**Lee Nuclear Station Units 1 and 2  
Description, Scope of Changes, and FSAR Impacts due to Plant Relocation and  
Additional Design Enhancements**

**Description and Rationale for Lee Nuclear Station Units 1 and 2 Relocation and  
Additional Design Enhancements**

FIGURE 2.4.5-202

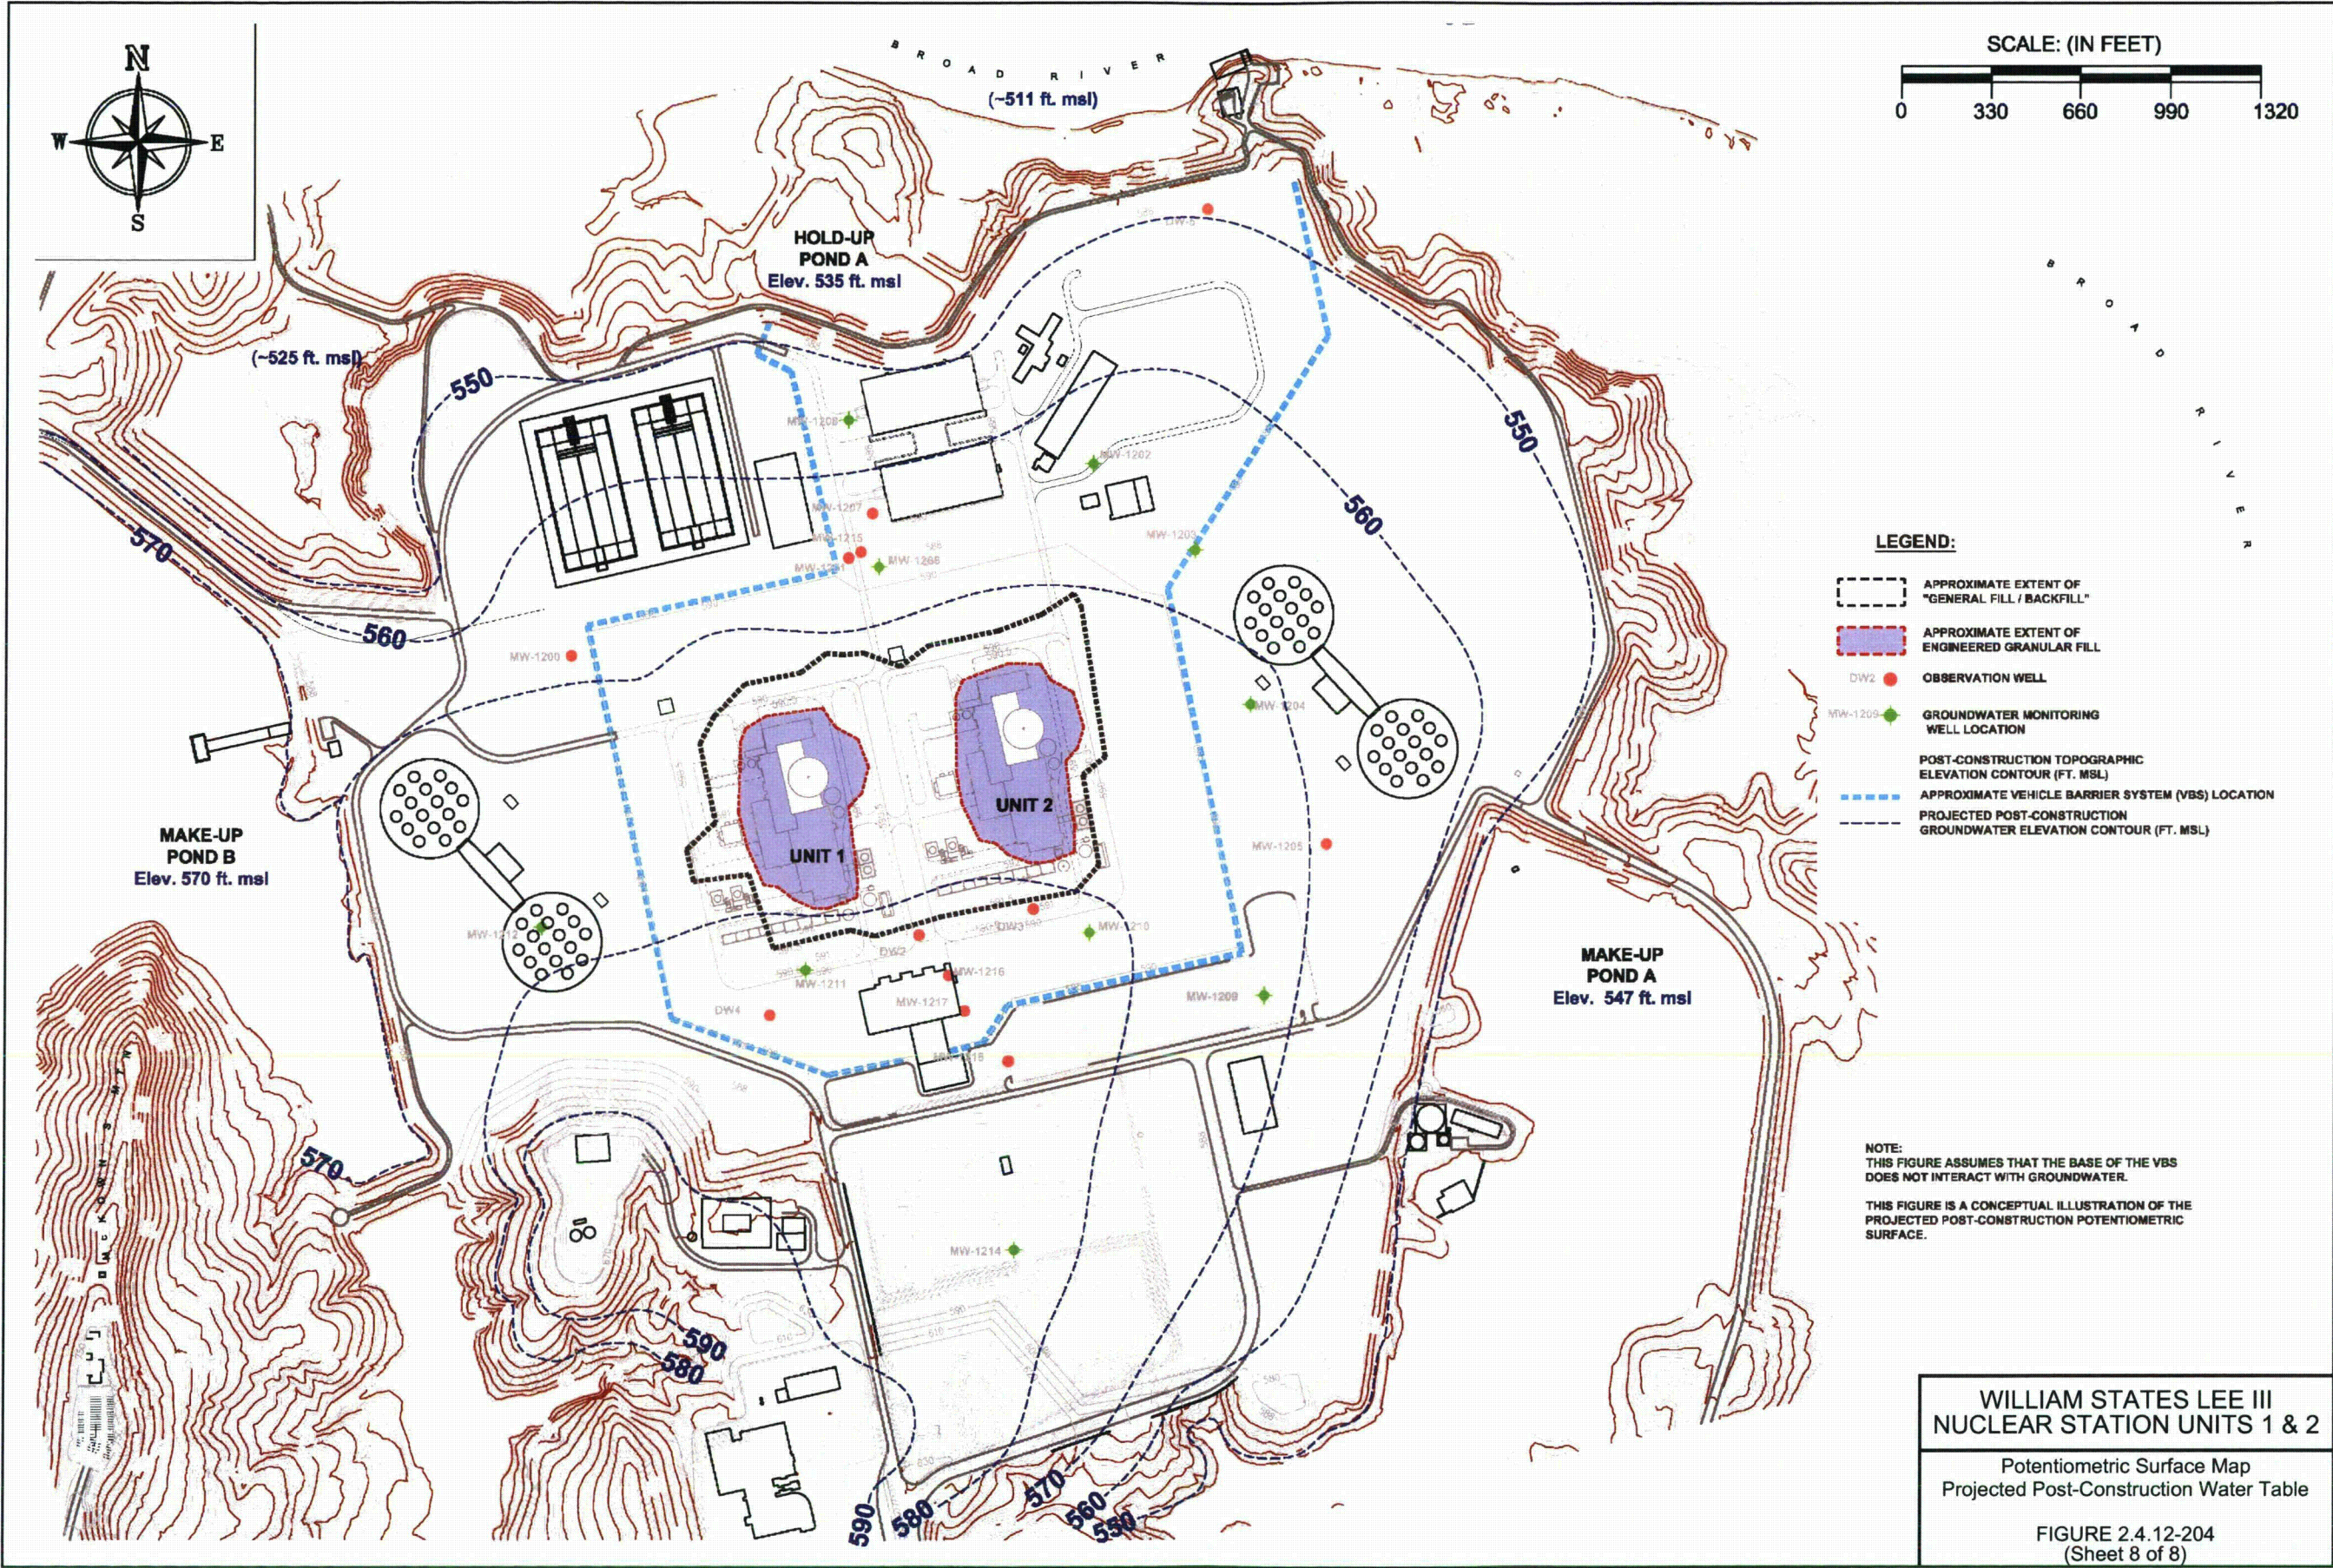
Make-Up Pond B surge flooding is evaluated coincident with the 100-yr. water surface elevation of ~~576.22~~ 576.18 ft. The critical fetch length is ~~4.30~~ 1.38 mi. as shown in Figure 2.4.5-202. The wind speed is adjusted based on the factors of fetch length, level overland or over water, critical duration, and stability using U.S. Army Corps of Engineers guidance (Reference 295). The critical duration is ~~26~~ 28 min. The adjusted wind speed is ~~90.489.9~~ 90.489.9 mph.

65. COLA Part 2, FSAR Chapter 2, Figure 2.4.5-202 is revised as follows:

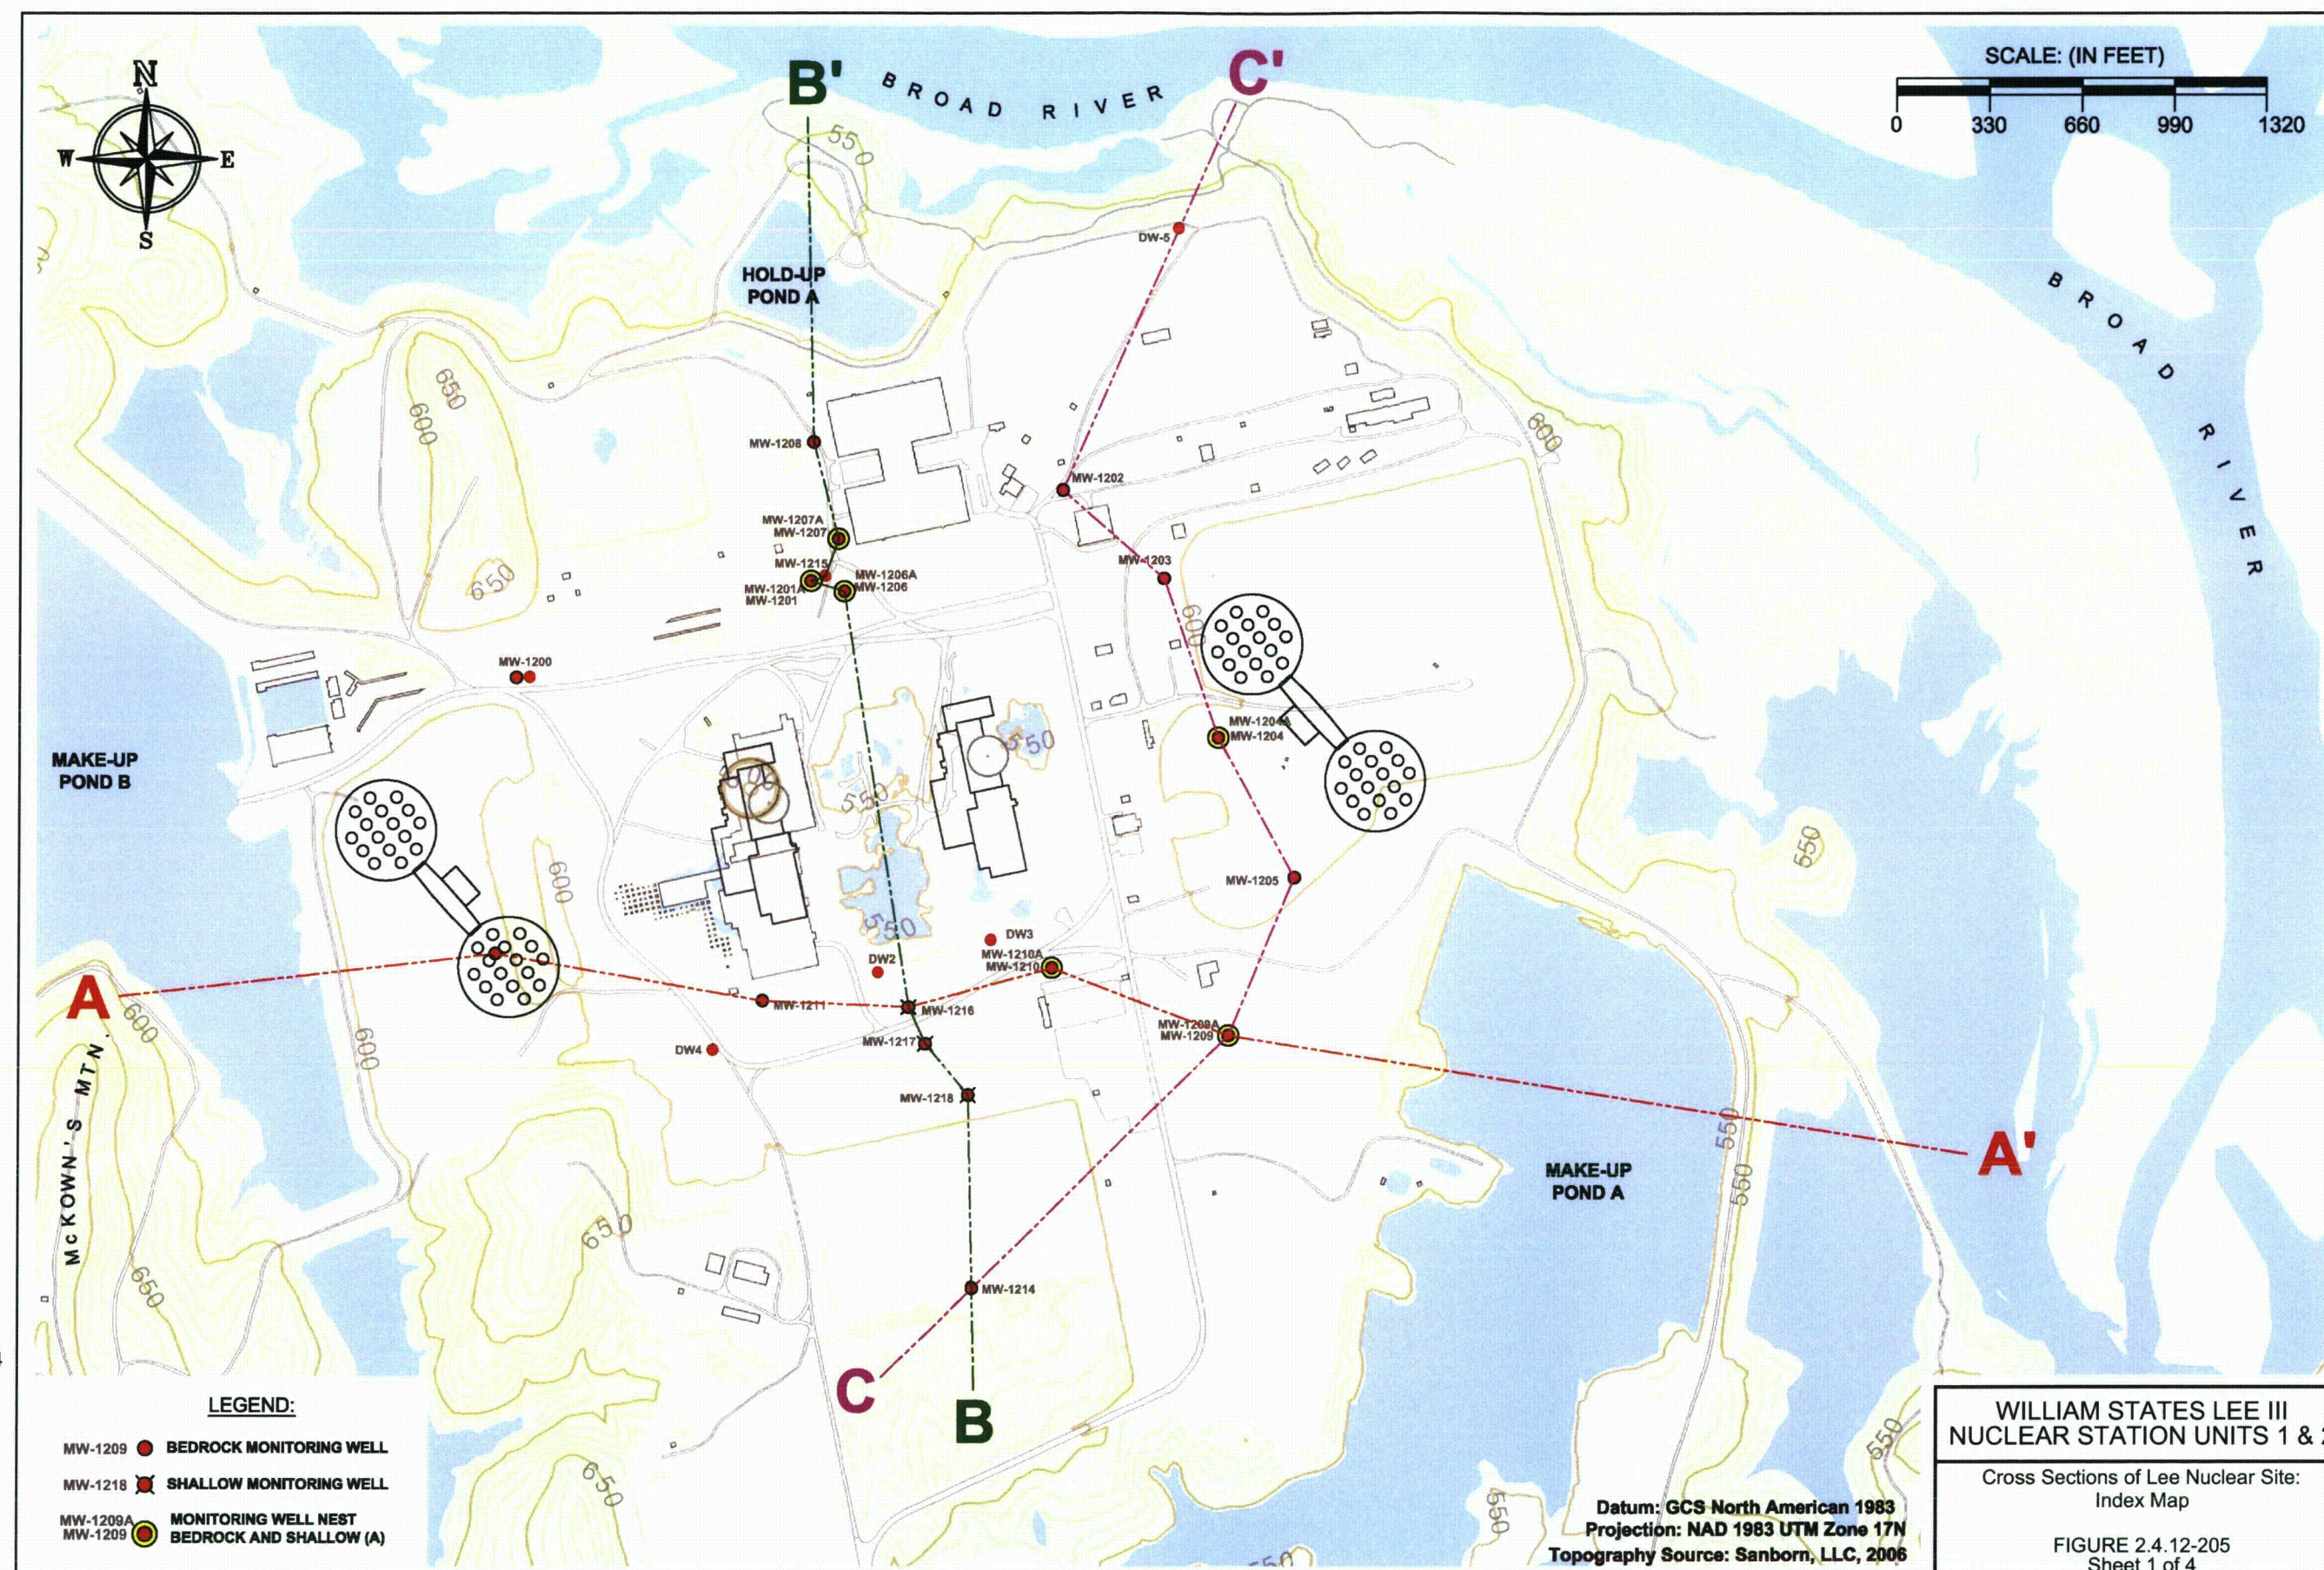
66. COLA Part 2, FSAR Chapter 2, Figure 2.4.12-204, Sheet 8 of 8 is revised as follows:

FIGURE 2.4.12-205  
Sheet 3 of 4

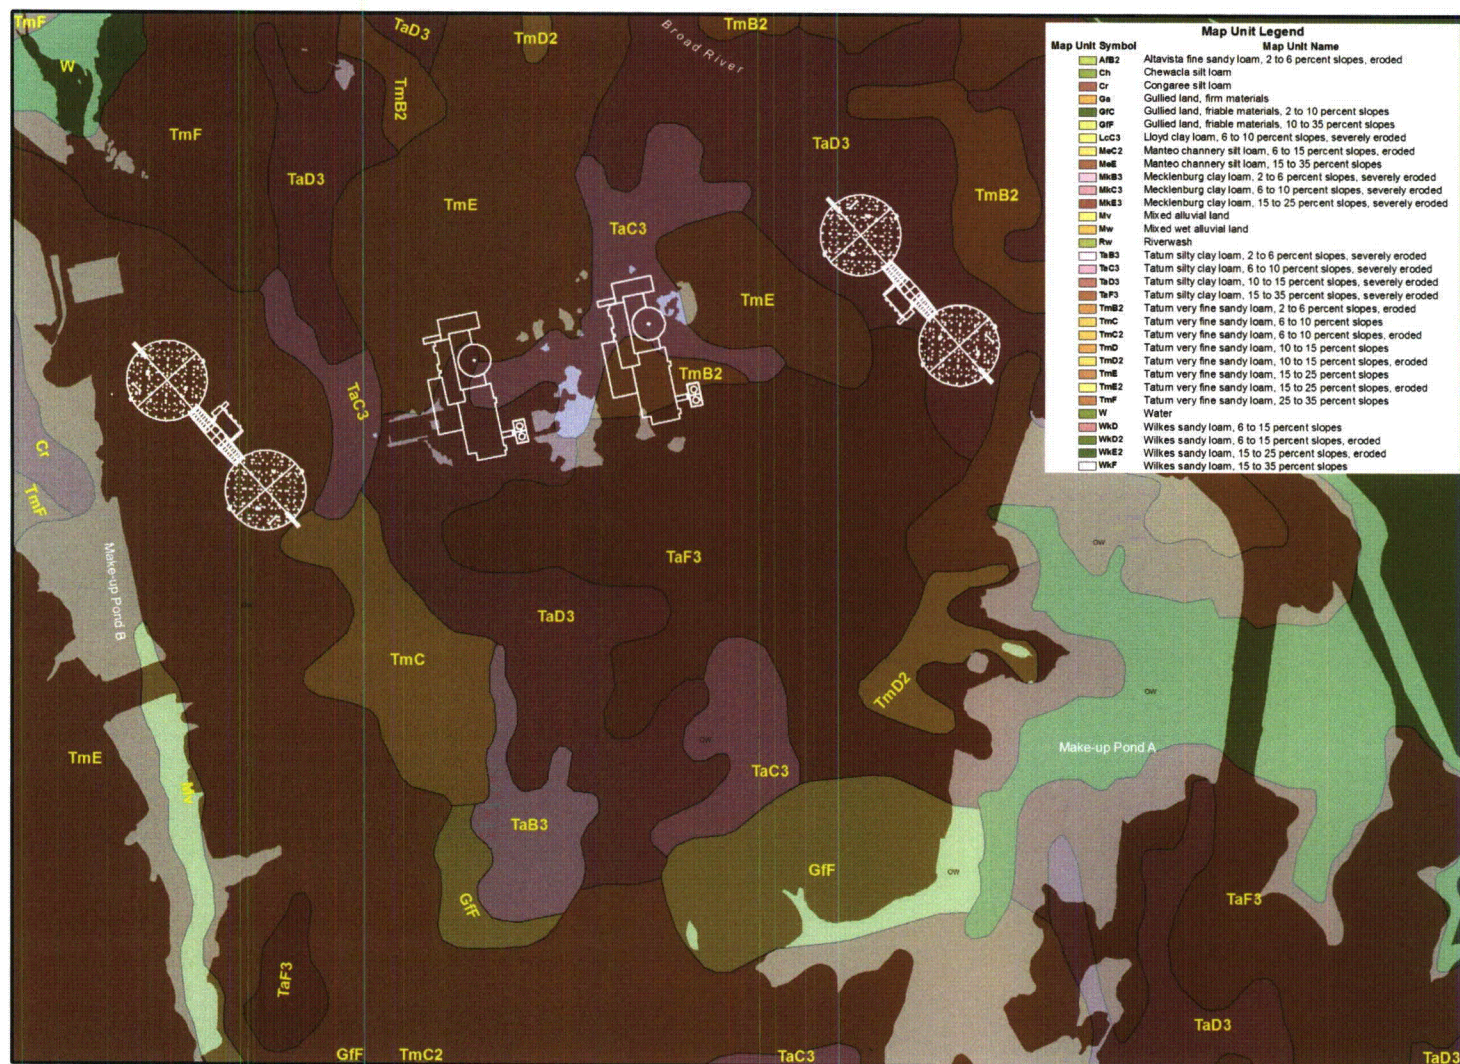
The conceptual model of radionuclide transport through groundwater, from Unit 2 to Hold-Up Pond A, is shown in Figure 2.4.12-205 (Sheet 3). As stated in Subsection 2.4.13.1, a direct conveyance between Hold-Up Pond A and the Broad River is assumed. With the failure of the effluent holdup tank and subsequent liquid release to the environment, radionuclides enter the subgrade soils at an elevation of ~~33~~32 feet 6 inches below the surrounding grade. The contaminated zone is, therefore, a volume of contaminated soil for which the effective porosity is saturated with contaminated water released from the liquid effluent holdup tank. The contaminated zone soil is assumed to exhibit PWR characteristics. Because RESRAD-OFFSITE considers soil at the source of the contamination, the liquid initial source term concentrations were converted to an equivalent concentration on a soil mass basis.
